ADDENDUM NO. 2

FY21 Stormwater Improvements
Project No. 21DPW12
Ayer DPW

LOCATION 8 - SAMANTHA LANE TREATMENT UNIT

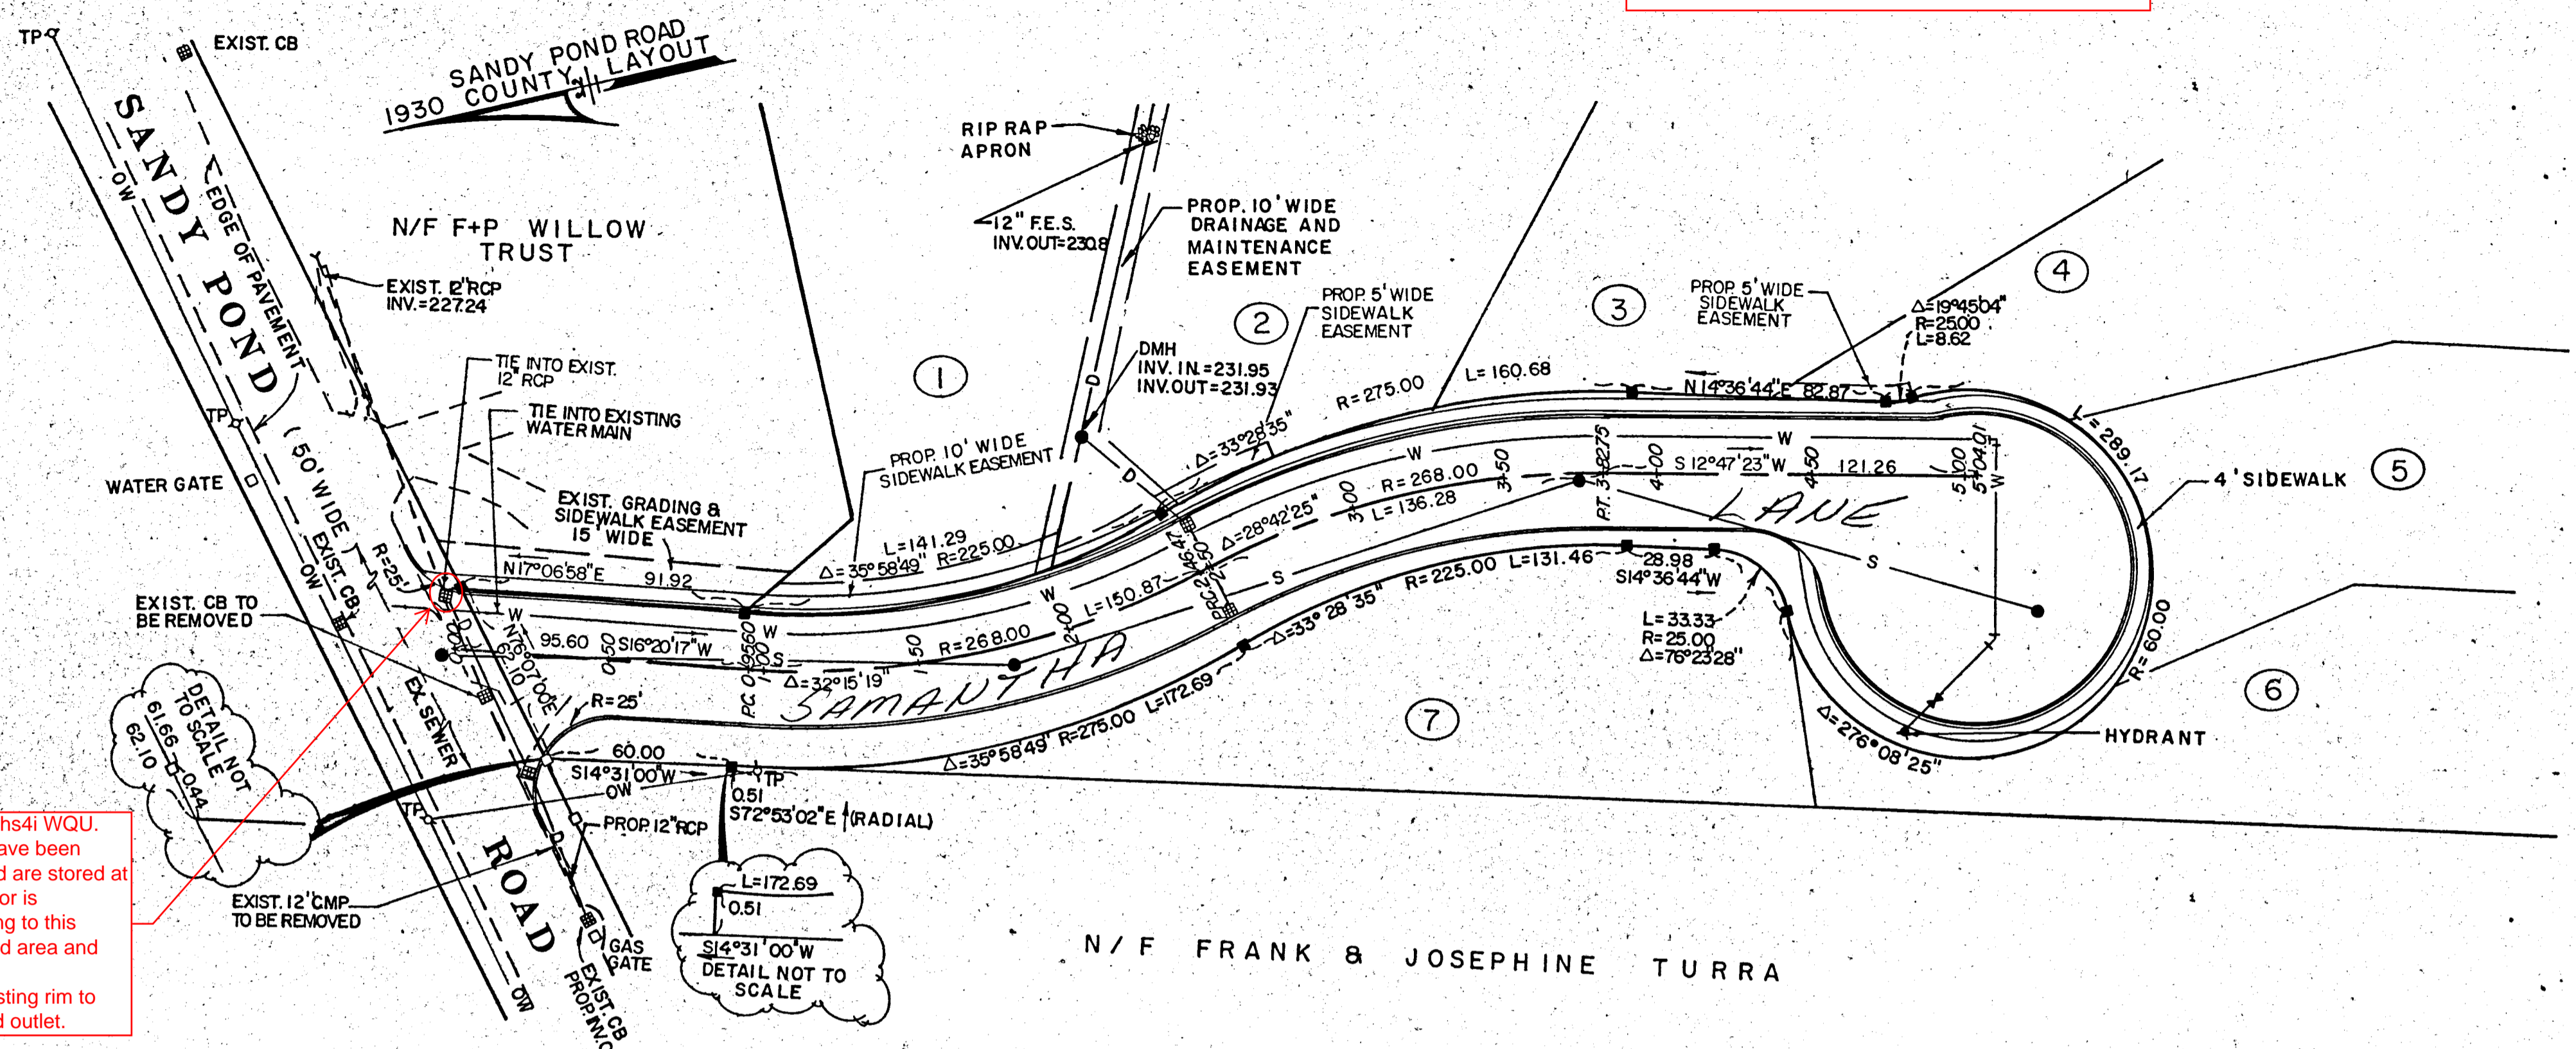
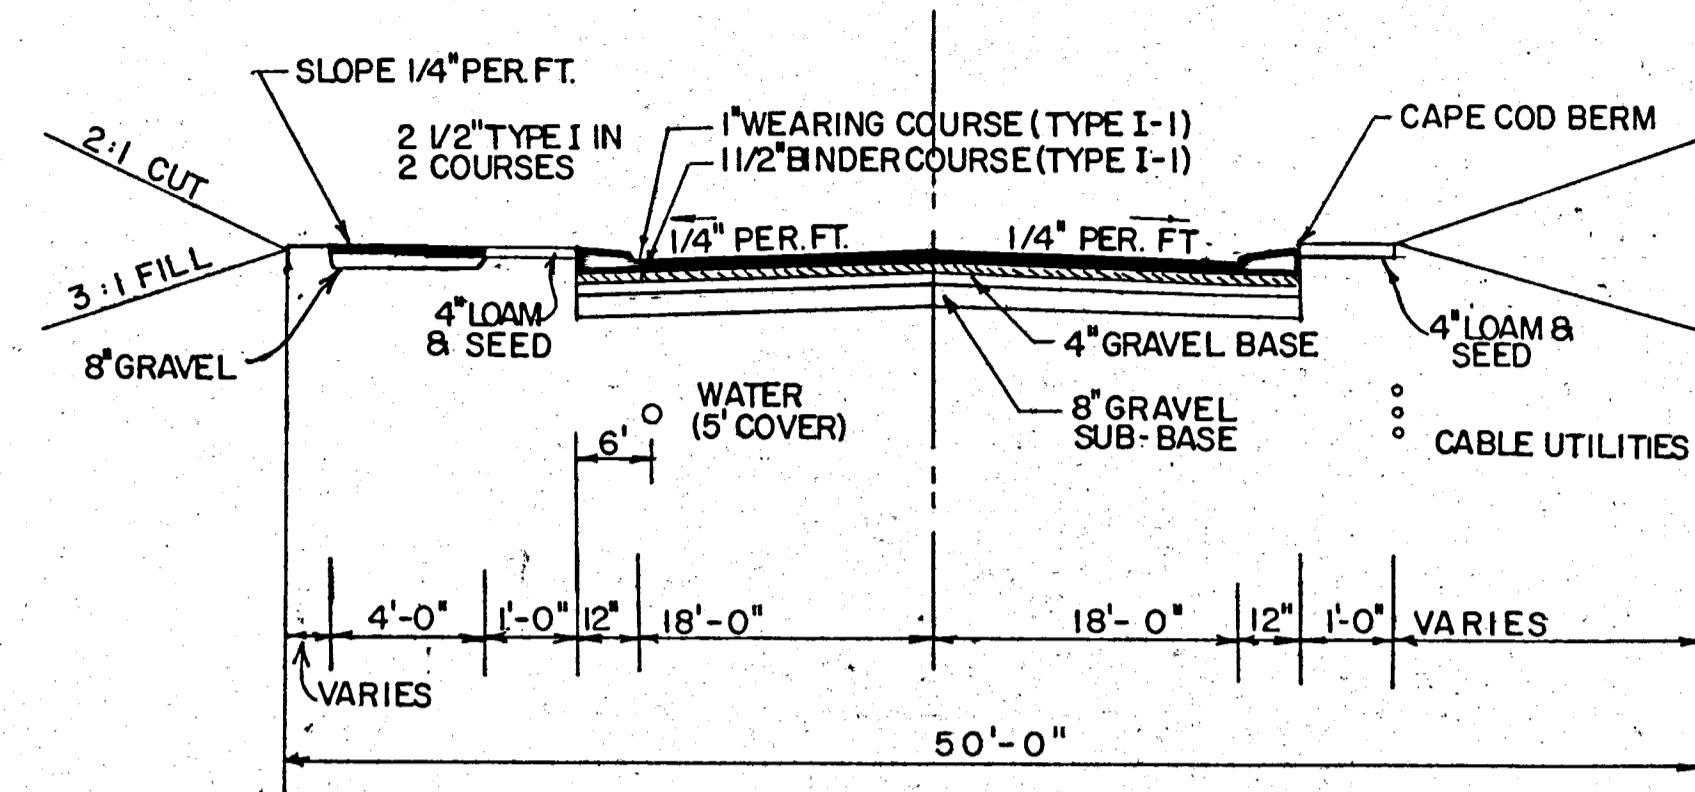
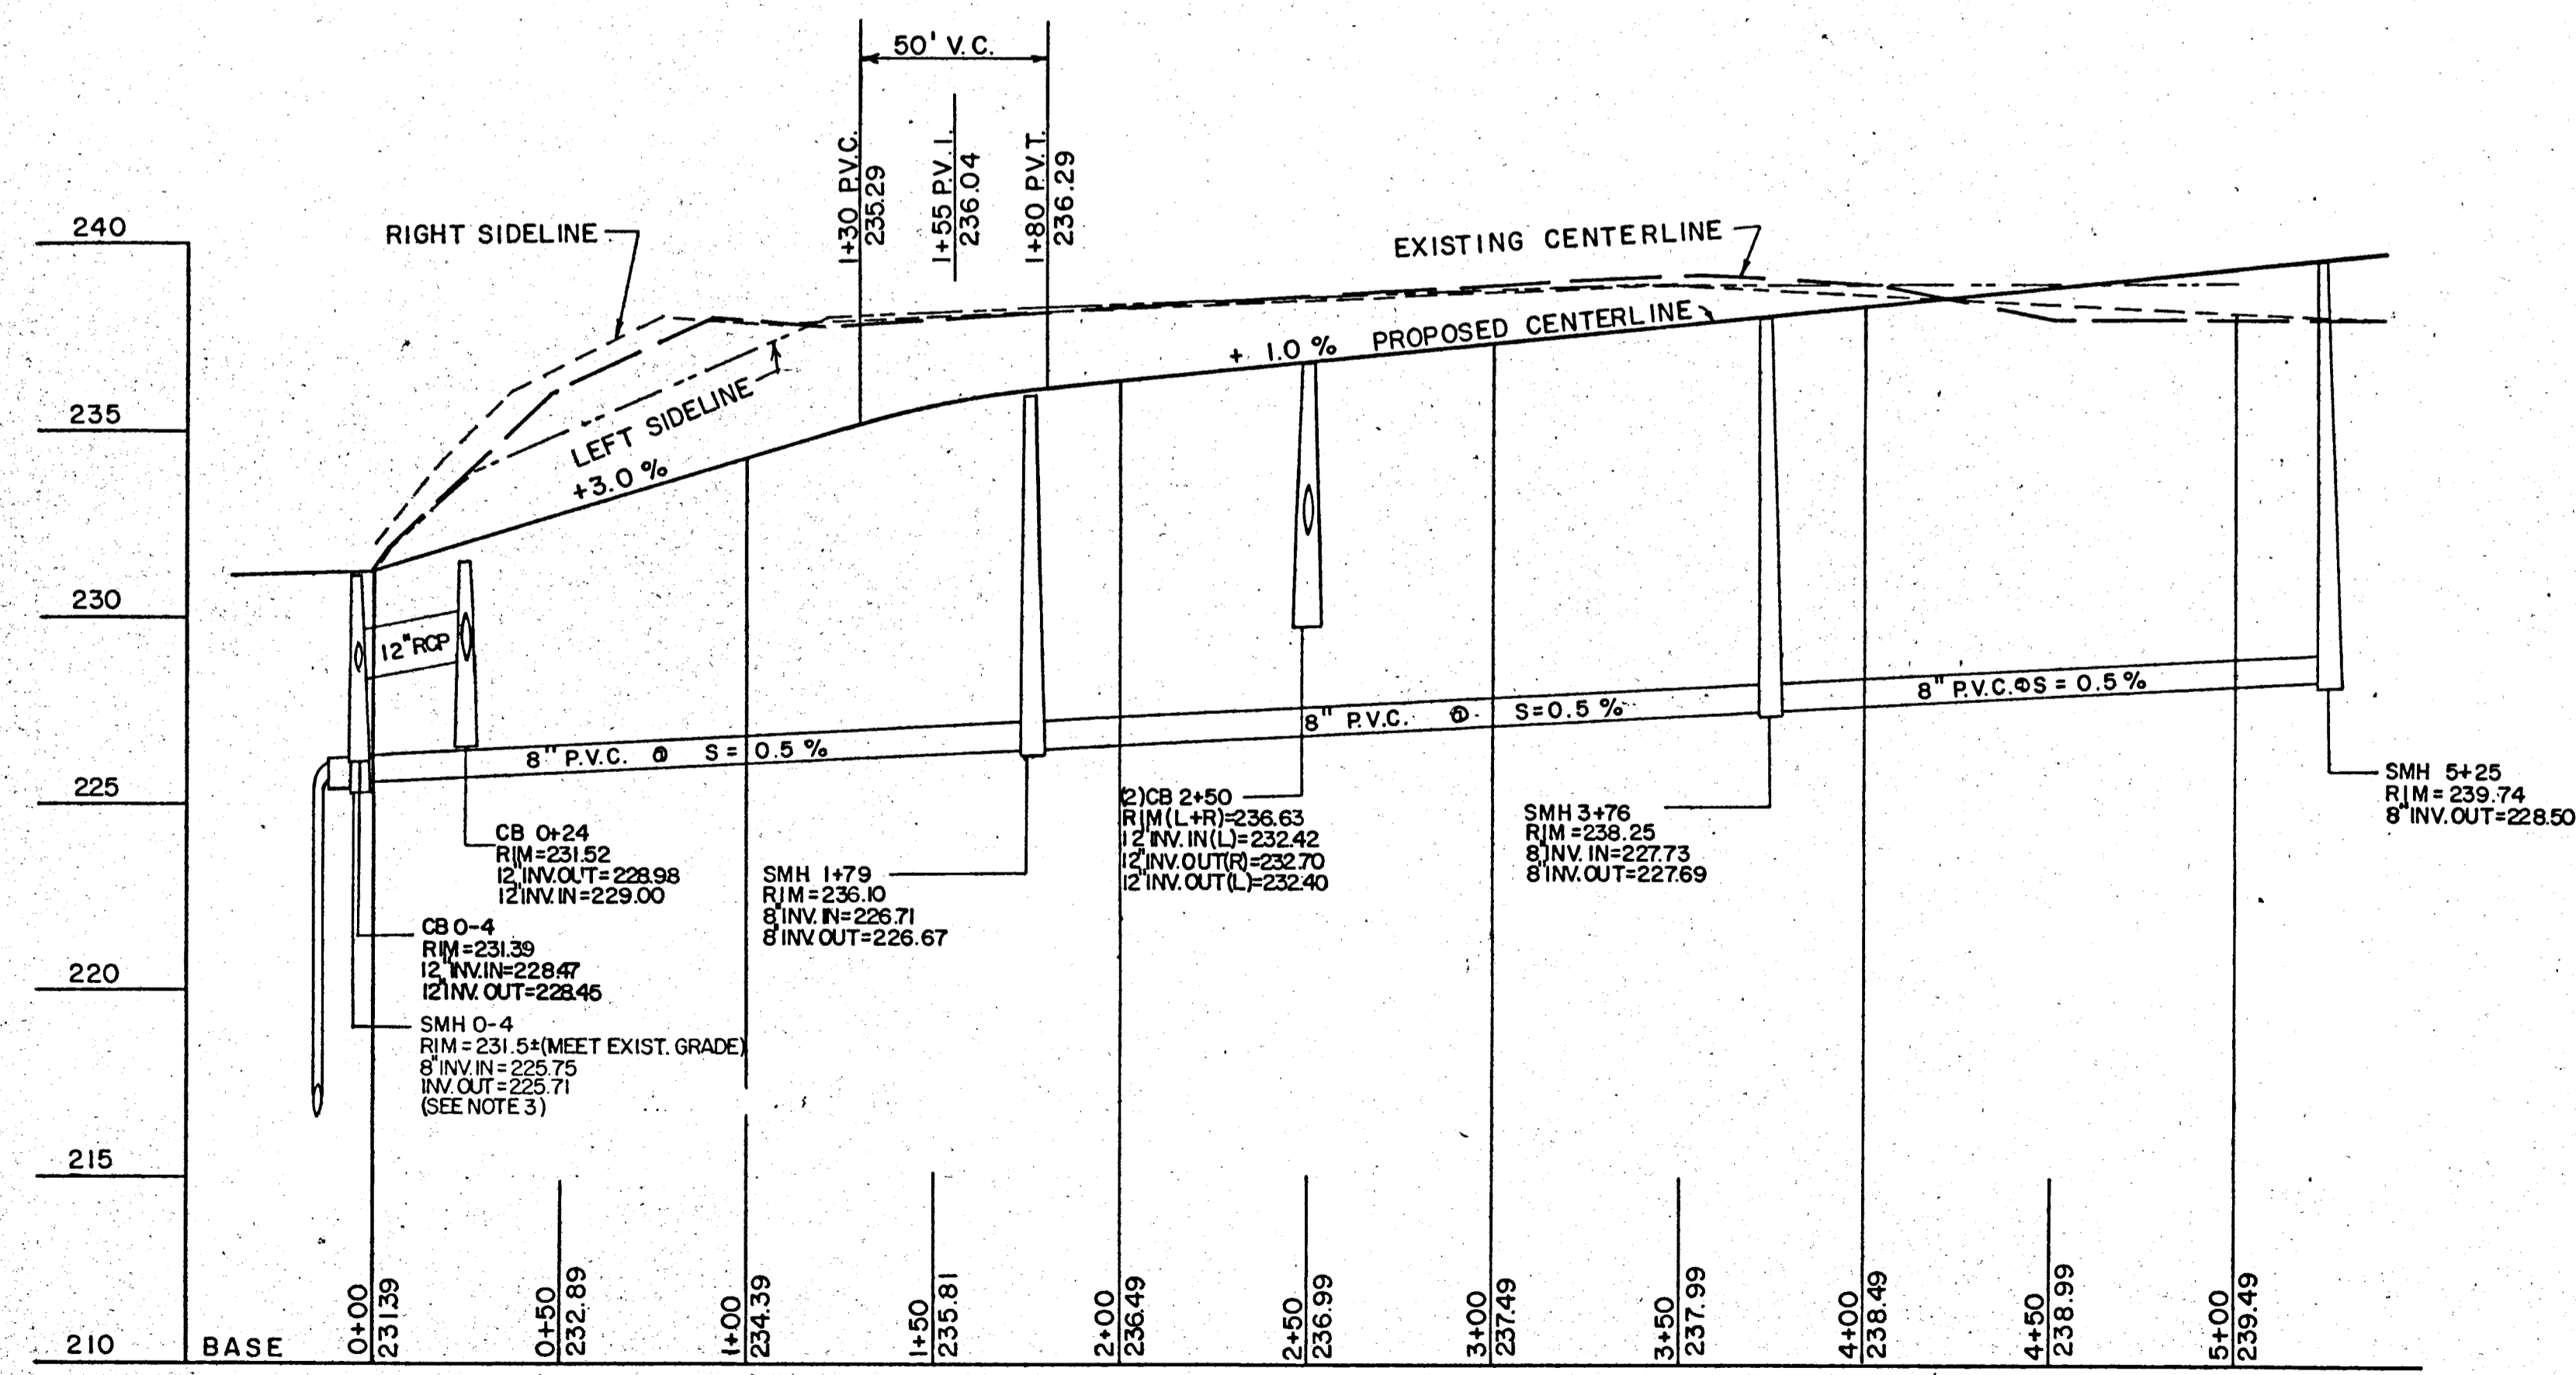
1. **REPLACE** FY21 STORMWATER IMPROVEMENTS OVERVIEW with the attached revised version. Location 8 has been changed from Highland Ave to Samantha Lane.
2. **REPLACE** LOCATION 2 – DOG PARK ROW BIOSWALE AND SIDEWALK CONNECTION with the attached revised version. The plan has been modified to include a fence.
3. **REMOVE** LOCATION 8 HIGHLAND AVE TREATMENT UNIT in its entirety. The work at this location has been removed from this project.
4. **INSERT** LOCATION 8 SAMANTHA LANE TREATMENT UNIT after LOCATION 7 BIORETENTION CELL 132 OAK RIDGE DRIVE. The Plan shows the installation of the stormwater treatment unit.

Replace catch basin with hs41 WQU, WQU, frame, and grate have been furnished by the DPW and are stored at 25 Brook Street. Contractor is responsible for transporting to this location. Restore disturbed area and repave to match existing.
 Note: Field measured existing rim to invert of 3-feet at inlet and outlet.
